## Design Review Board

October 10, 2018

# Lewis & Clark High School Addition

### Design Review Staff Report

## LANDSCAPE PLAN

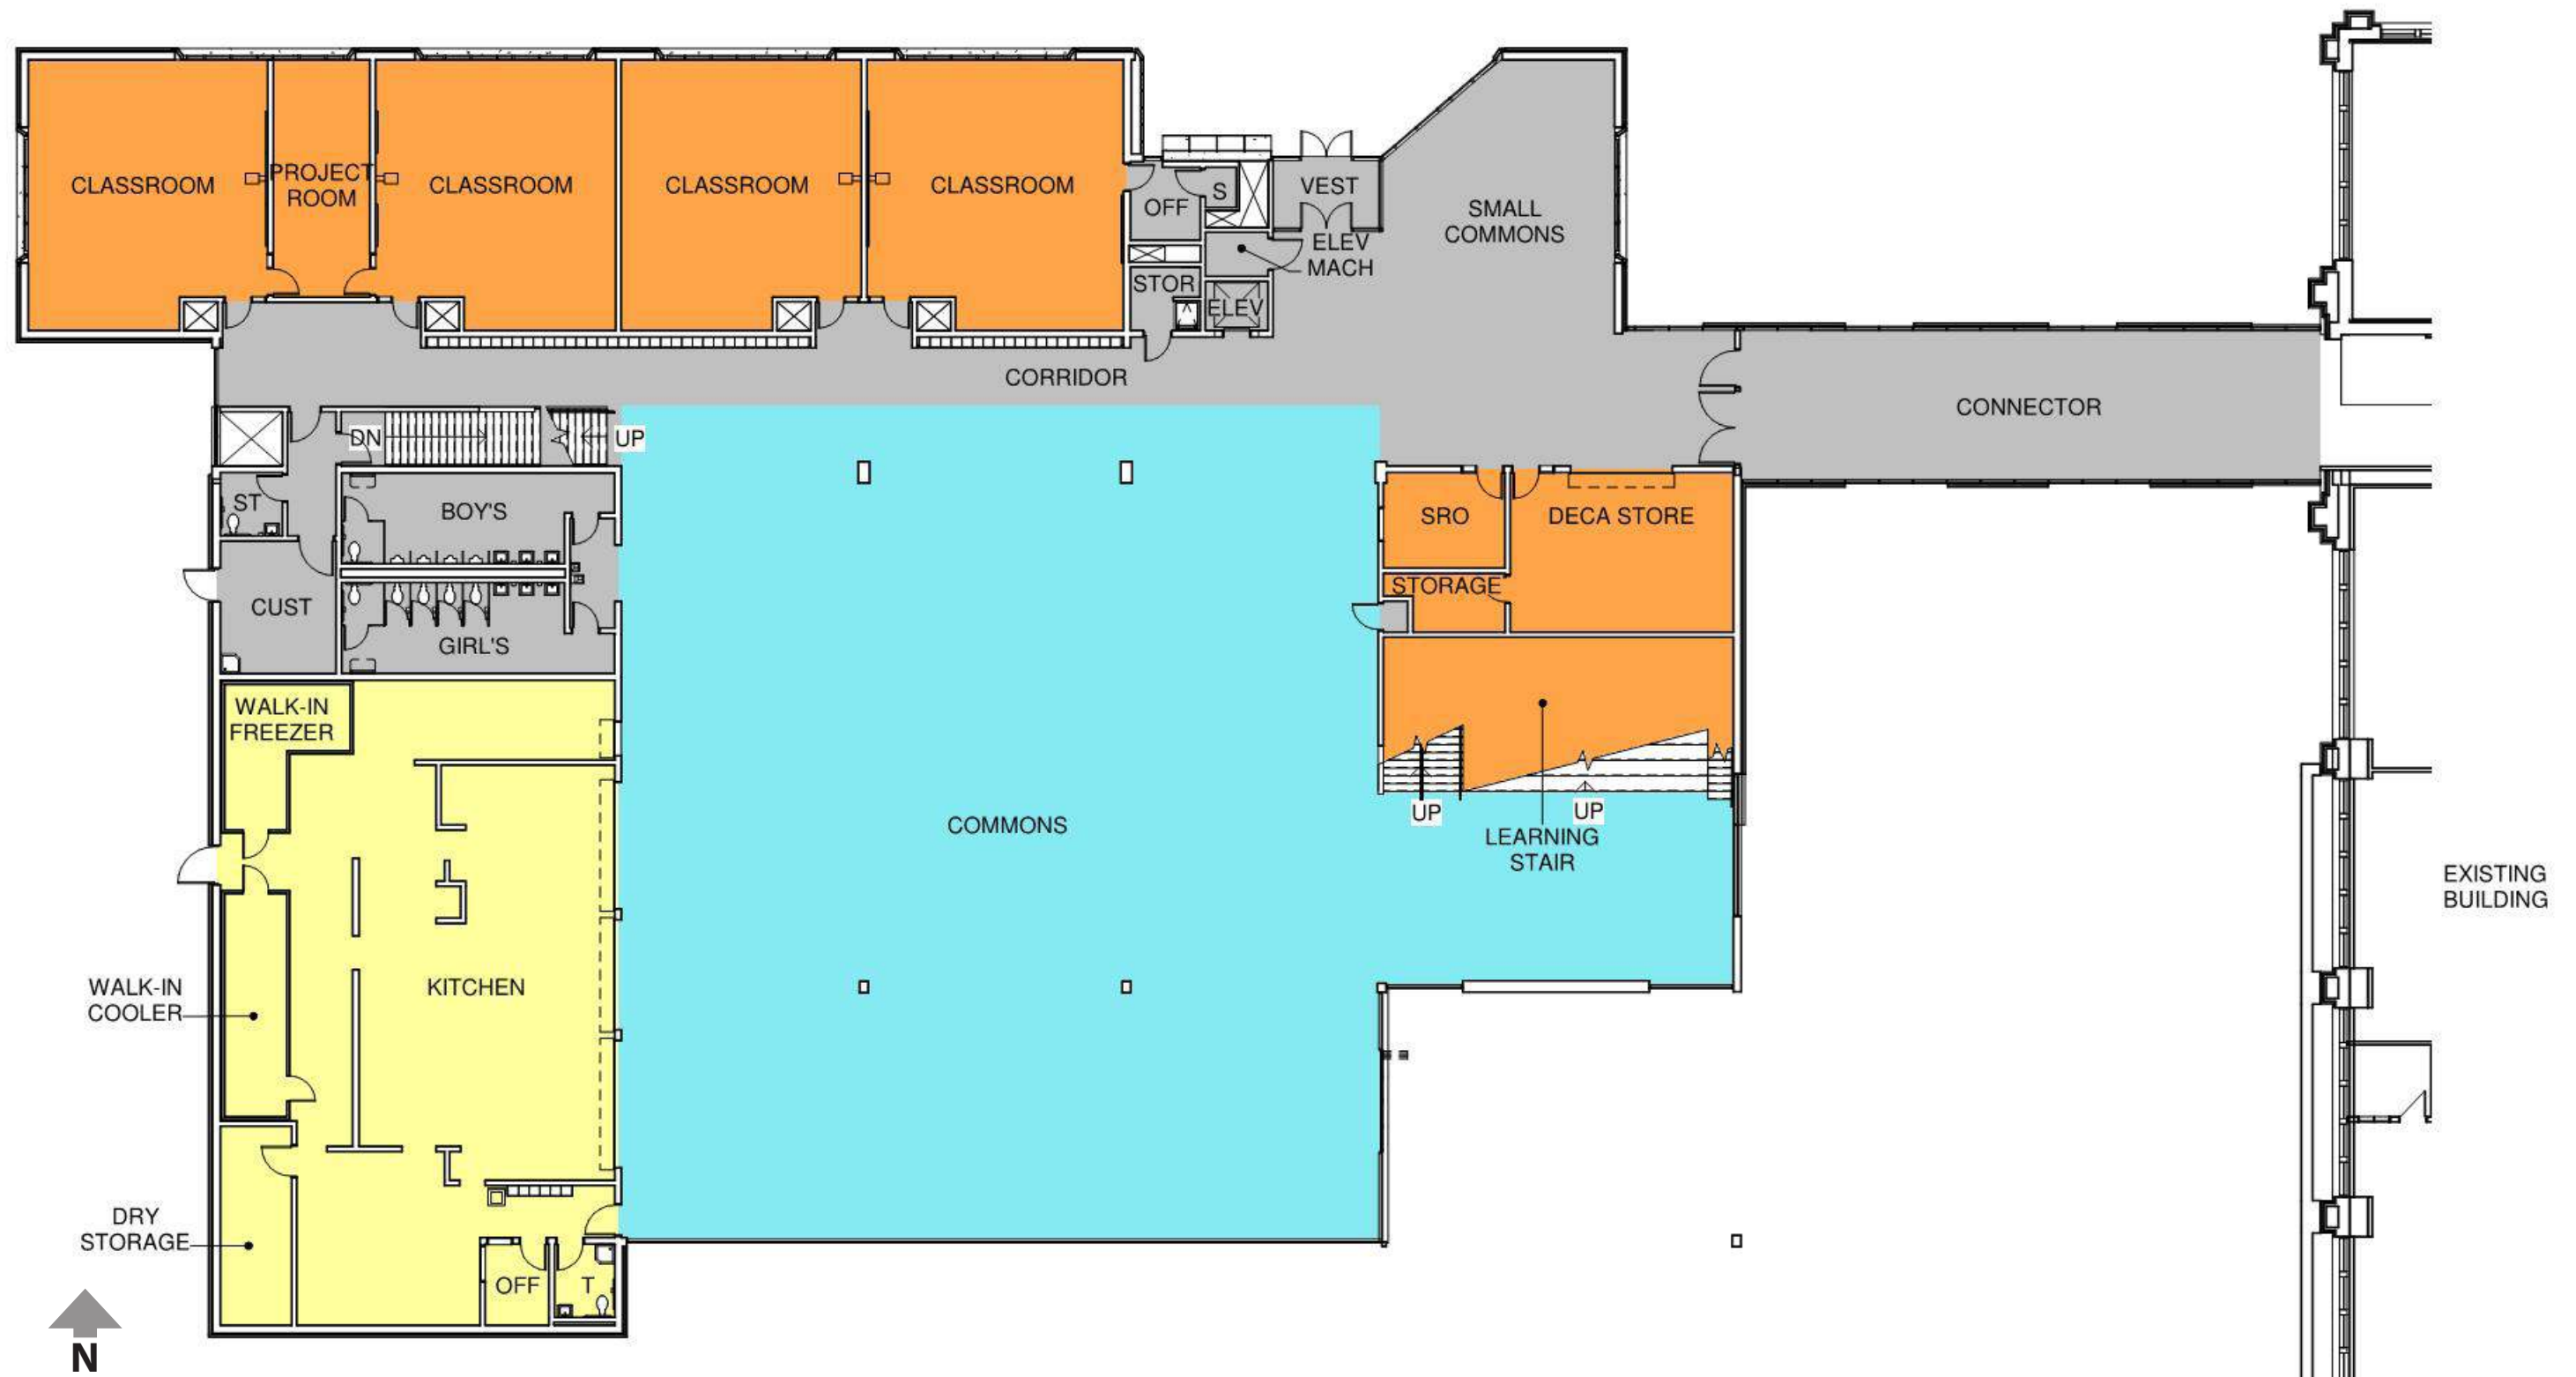
5. The applicant shall return with a more well-refined configuration for the proposed plazas – specifically in regards to site access, seating, and programming.

6. The applicant shall consider the solar shading benefits of coniferous trees – especially in regards to prominent window glazing.

3. Approximately five deciduous trees within the Howard Plaza area will be lost to make way for the addition's footprint. Six of the eight deciduous trees located behind the sidewalk along Wall St. are also slated for removal to make way for the addition's western footprint and associated utility yard. Additionally, five conifer trees near the south fence, the associated linear plaza and paved pathway (with four benches), and pedestrian fence gateway near the NEC of Wall St. & 5<sup>th</sup> Ave. are also slated for removal. Is the planting of two new Linden trees (to be located near the south fence, west of the off-street accessible parking space), the creation of a new ~15,000 square foot passive turfed yard, the construction of a ~12,500 square foot stepped plaza, and the planting of ten new street trees (within planter beds) sufficient to mitigate the proposed loss of vegetation?

4. Though no detail is yet provided for the new street trees to be planted along Wall St., the landscape plan implies that these five tree couplets will be planted in a landscaped bed. Since the entire Wall St. frontage will be utilized for both delivery vehicle staging (for the commercial kitchen) and twice-daily bus parking (for drop-offs and pick-ups), shouldn't these back-of-curb street trees be placed in tree wells with grates?

*See attached site and landscaping plan showing extent of south side student courtyard. The design intent is to provide a variety of zones from passive to active in the menu of outdoor spaces.*

*See attached site and landscaping plan showing extent of existing trees to remain. It was decided that in order to provide a large enough outdoor active zone that the 5 ponderosa pine trees in the center of the lawn would need to be removed. The rest of the trees at the perimeter will be preserved and new street trees along the south edge are being proposed to give good solar shading during the warmer months and allow for more solar access in the winter.*

**1** EXISTING EAST ENTRY  
Scale: 1/4" = 1'-0"

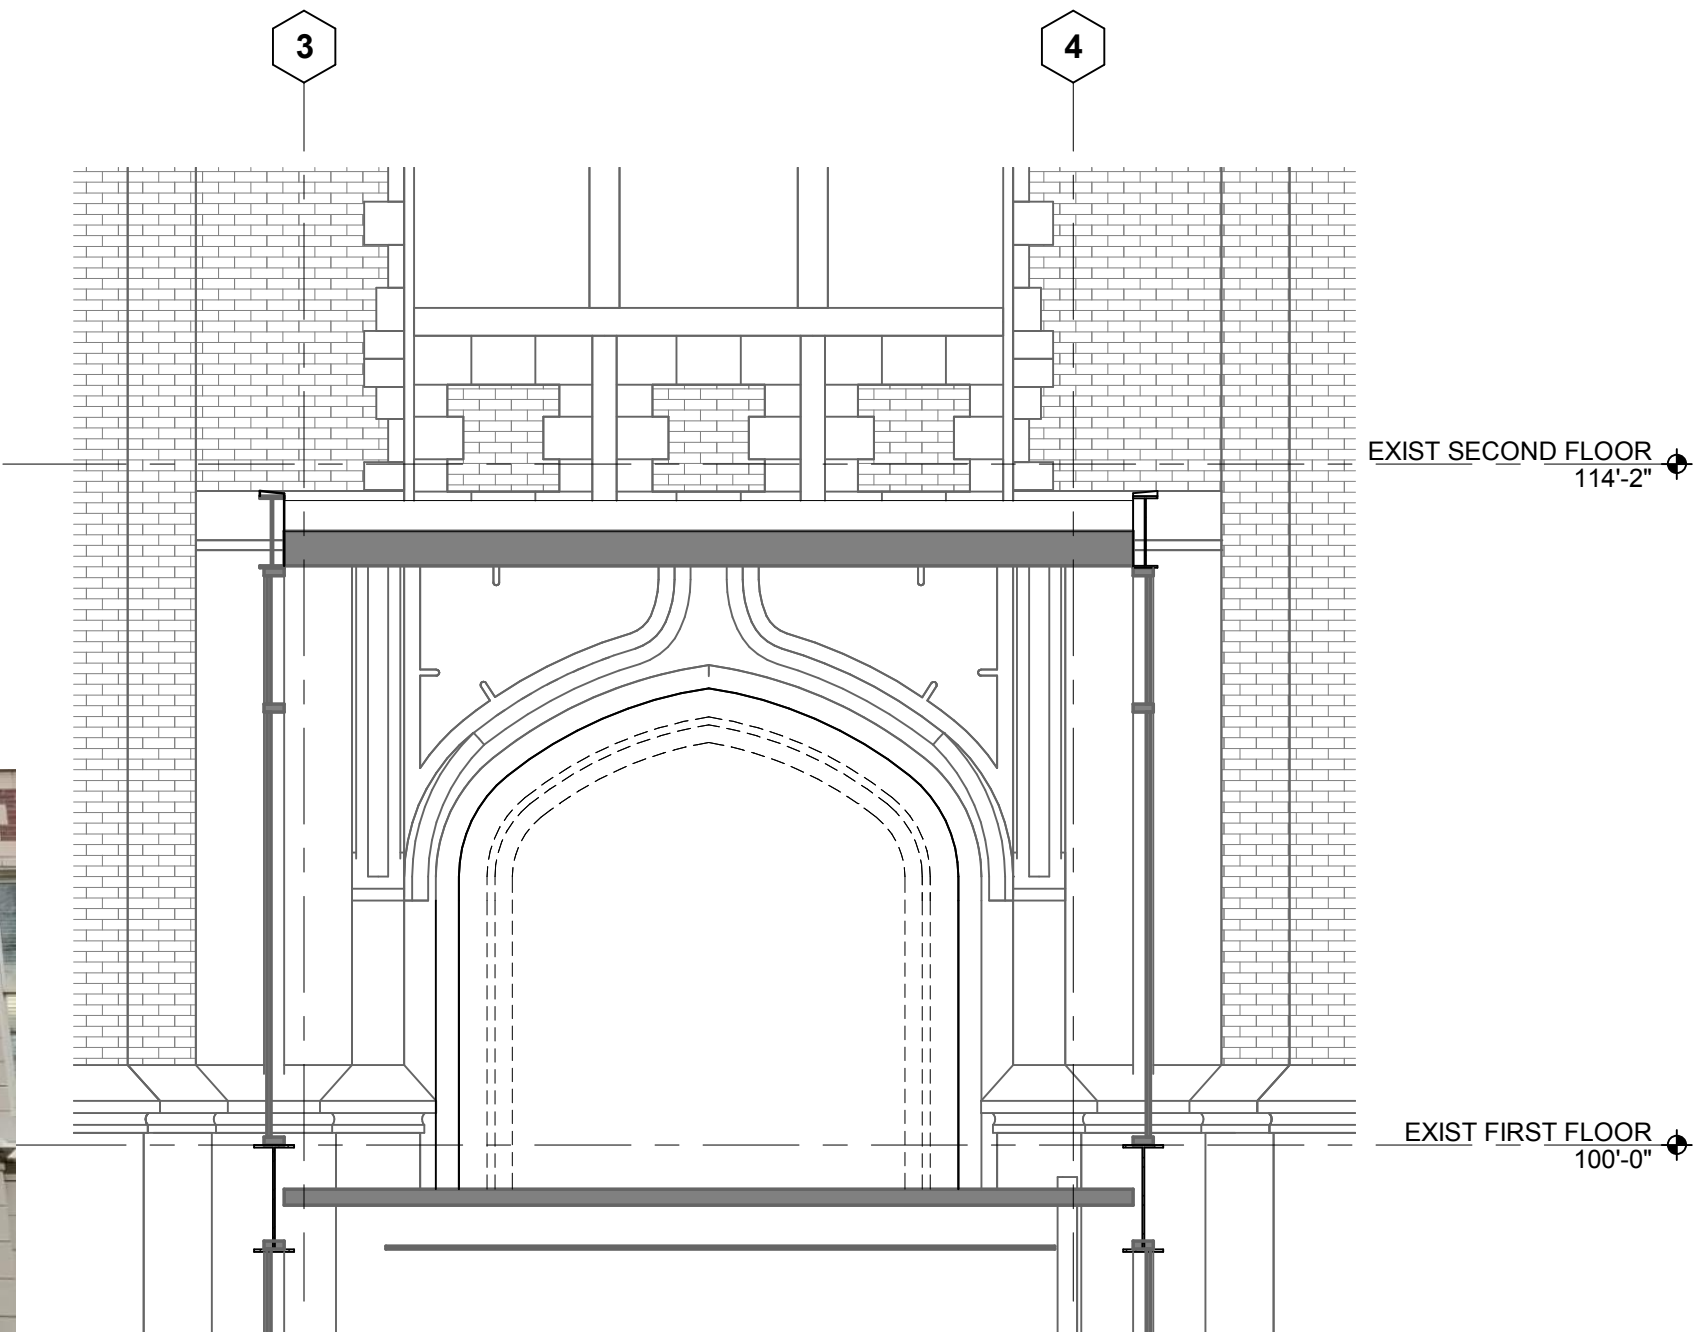
1. You've stated that it's NAC's intent that the architectural elements of the southwest (*sic*) entrance of the main facility (which you've referred to as the west elevation's "architrave") will be preserved to some extent, and one of the photorealistic renderings indicates the four-centered Tudor arch staying in-place. It appears that the bottom of the arch's lowest radius is about 5'-6" above the second floor's finish elevation, and the addition's second floor plan shows a ramp at the eastern end of the new corridor-connector. Is it NAC's intent that the terracotta archway will remain and that the two-story steel & glass corridor will bracket (or frame) the arch?

1. I (staff) quickly put together the attached image based on the A1 image you submitted earlier. I've shown shaded in red the portion of the terracotta arch that you plan on removing, and the transom window hatched in green that you plan on relocating to the new addition. Let me know if this is correct.

1. The applicant proposes a partial demolition of the terracotta four-centered Tudor Archway at the northwest entrance to the existing historic facility, what opportunities exist to keep the full terracotta elements of the archway (or what, if any, prohibitions present themselves)?

2. The applicant proposes salvaging the existing wooden transom window from the northwest entrance's archway, and relocate it to the new addition. Where in the new addition will the transom be relocated to best highlight this conservation?

*Yes, see attached drawing A1; in order to maximize the width and height of the opening we are removing the jamb piece which increases the width and height by 34" & 17" respectively. We also hope to salvage the transom window to be incorporated somewhere in the new addition entry area.*

*Yes this is correct.*
